## Education Center at the Wall

June 1, 2015  
Project Report  
Vietnam Veterans Memorial Center – Education Center at the Wall  
National Capital Planning Commission

APRIL 2014  
COMMISSION OF FINE ARTS - COMMENTS

# 2015 Site Plan Comparison

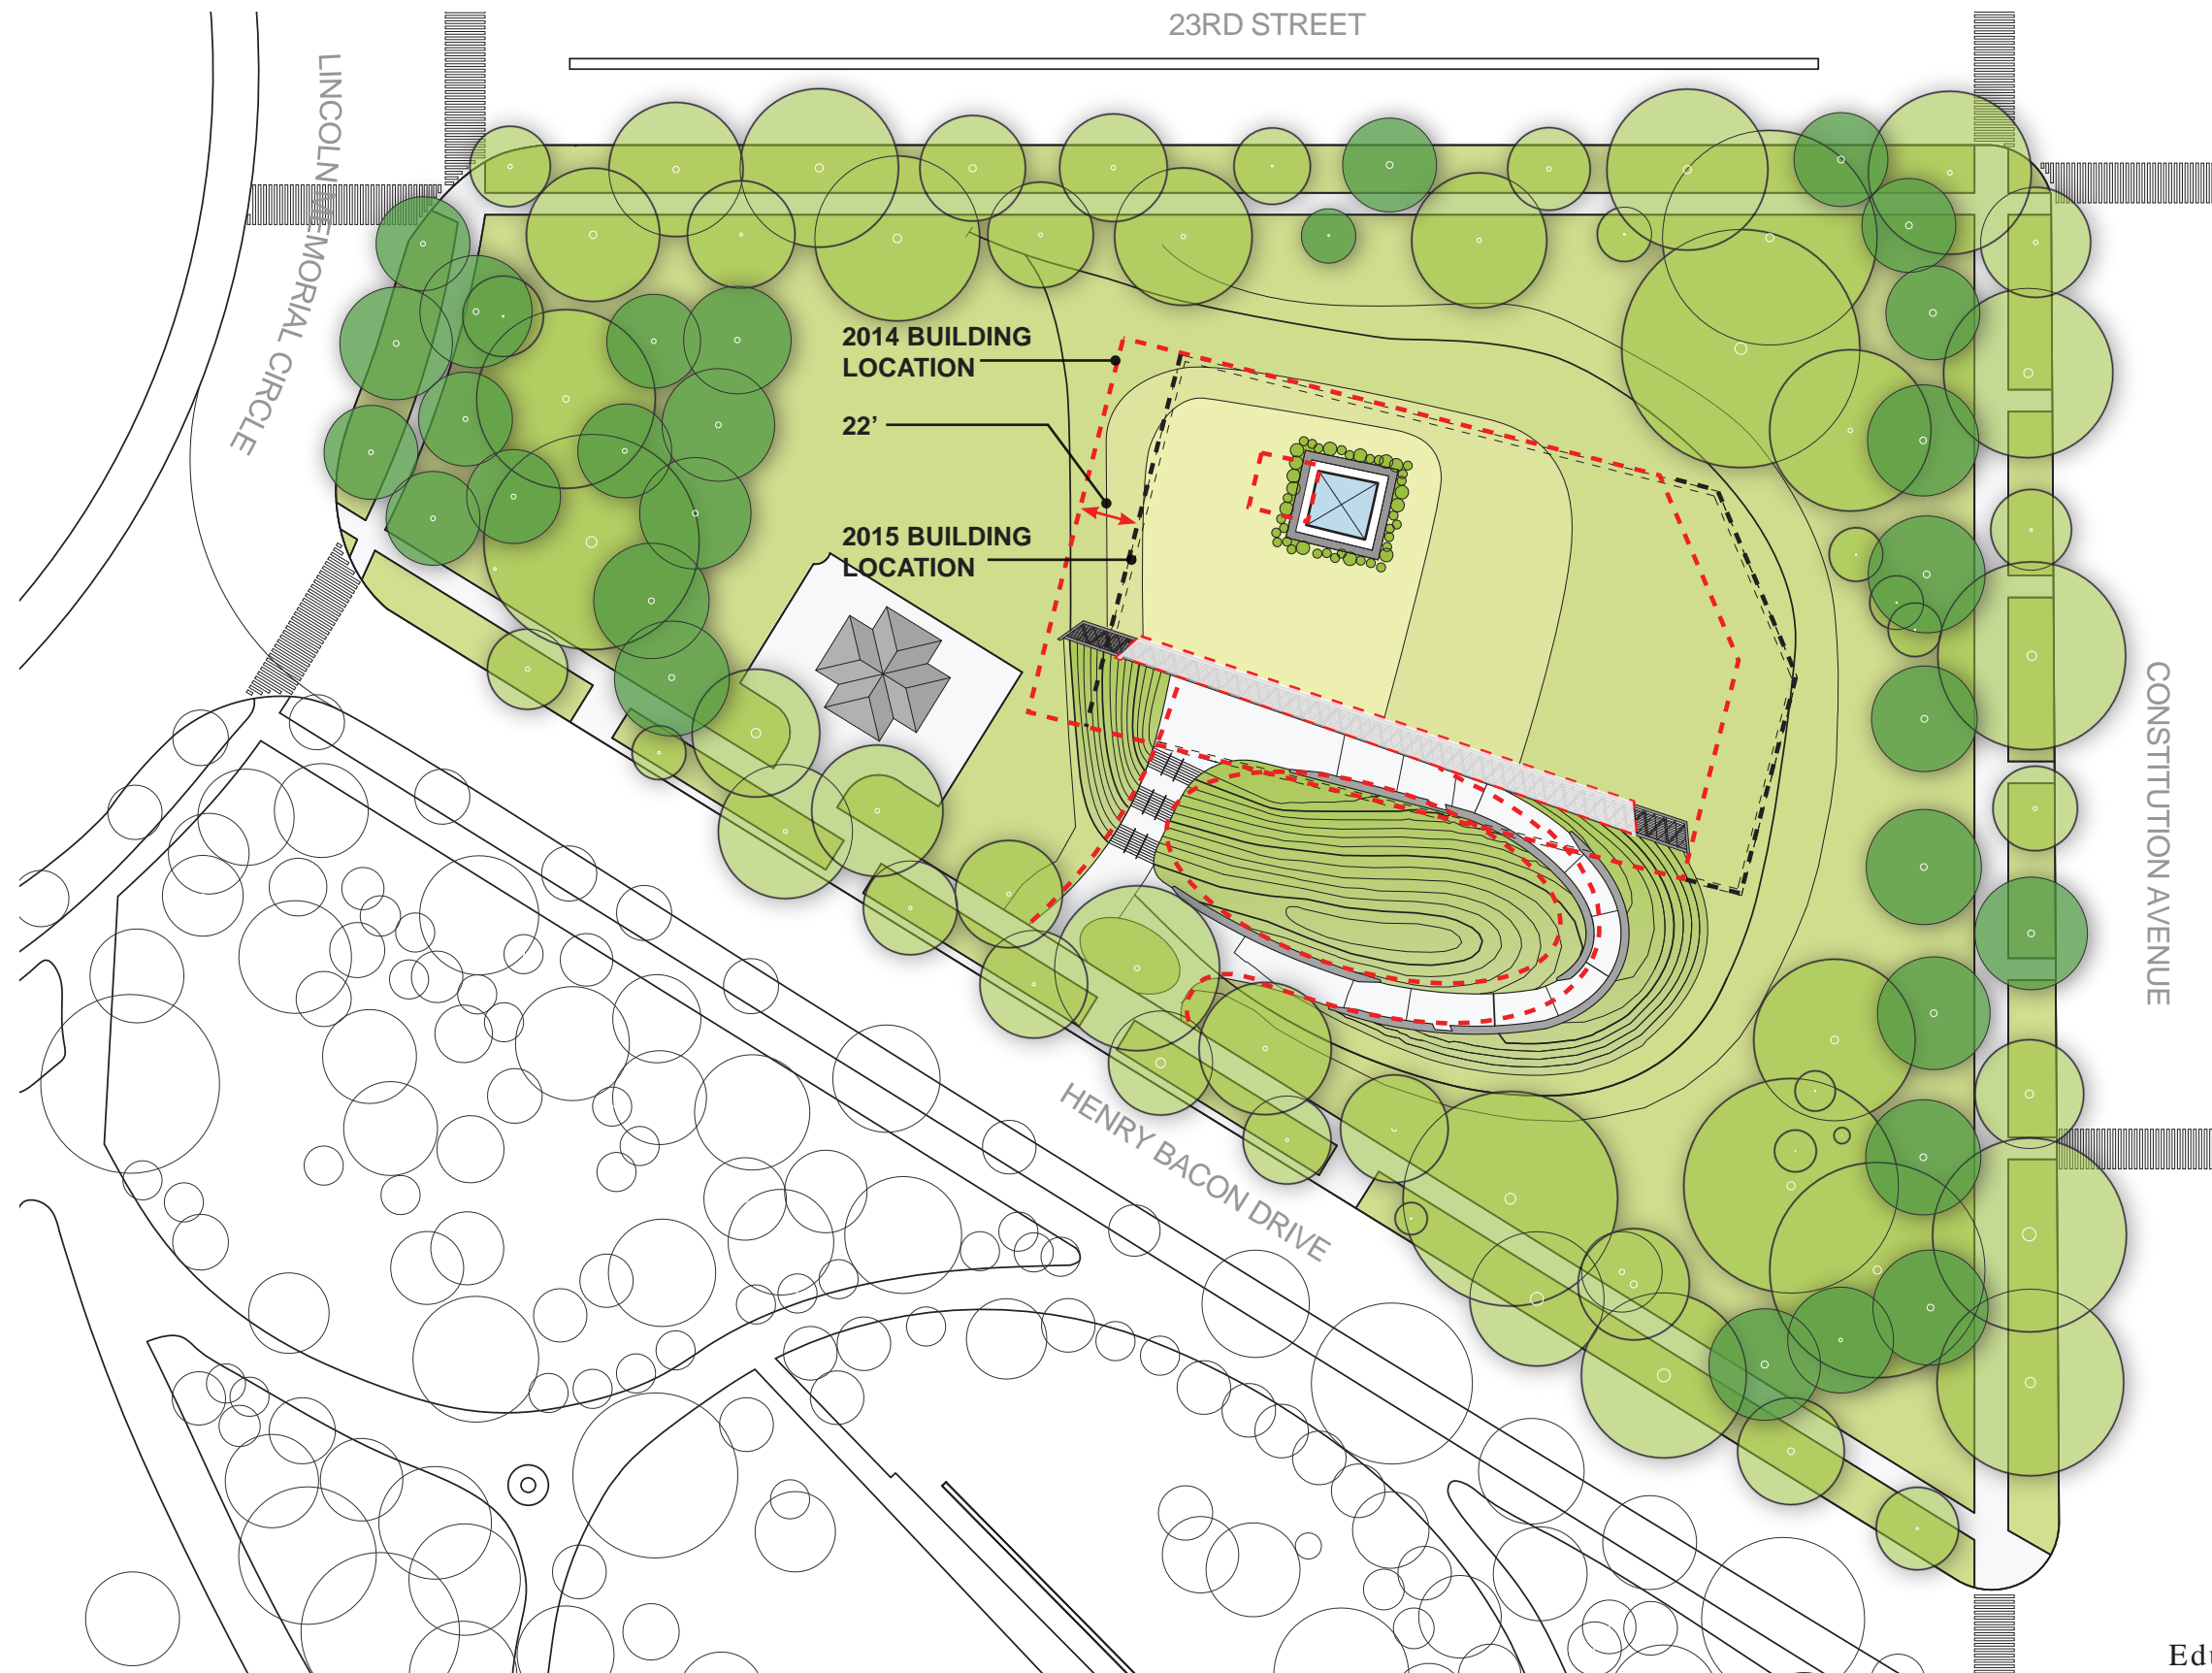
- Removal of the retaining wall adjacent to the entry stair, citing concern from the Commission of Fine Arts of the similarity in appearance of the two perpendicular walls at the entry to the Vietnam Veterans Memorial itself. In lieu of this retaining wall, a gradual grass berm at a 3:1 slope has been incorporated into the landscaping.

- Reshaping of the grass berm defined by the surrounding entry ramp to be more organic and less figural than the ellipse included in the former design, thereby bringing the design of the landscape more in line with the language of the National Mall.

- A slight shift of the building within the site toward the North, as required to make the new grass berm feasible in relation to the location of the adjacent National Park Service kiosk.

- A recalibration of the entry stair and the entry doors to the Center such that the stairs end on axis with the doors. Formerly, the entry stairs directed visitors to approach the courtyard and the entry doors were adjacent in a covered “forecourt”.

- Revision of the Entry and Lower Level floor plans to accommodate the changes at the main entry and the adjacent exit stair, required as a result of the removal of the retaining wall described in item 1.

1. Replaced Entry Retaining Wall with Grass Berm
2. Reshaped Entry Pathway and Ramp
3. Reconfigured Building Entry and Lower Level Plan

RE: Vietnam Veterans Memorial Center; Revised Design to Eliminate Entryway Wall, Eliminate an Additional Skylight, Simplify Ground Plane Planting & Relocate One Tree

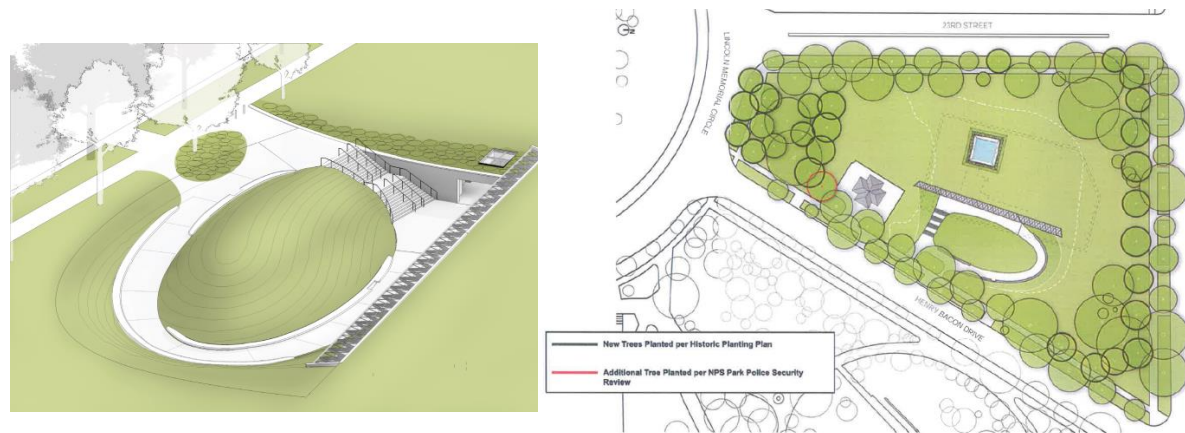
Based upon our review of the most recent plans, we understand that designs which we commented upon on January 16, 2014 (image below on the left) have been revised so that the wall along the entryway and one additional skylight will be removed, the ground plane planting plan will be simplified and one additional tree will be planted for security reasons (image below on the right). As before, we concur with the NPS determination that these additional revisions will not result in any new or intensified adverse effect on historic properties. Therefore, no further consultation with our office will be necessary regarding the revised designs.
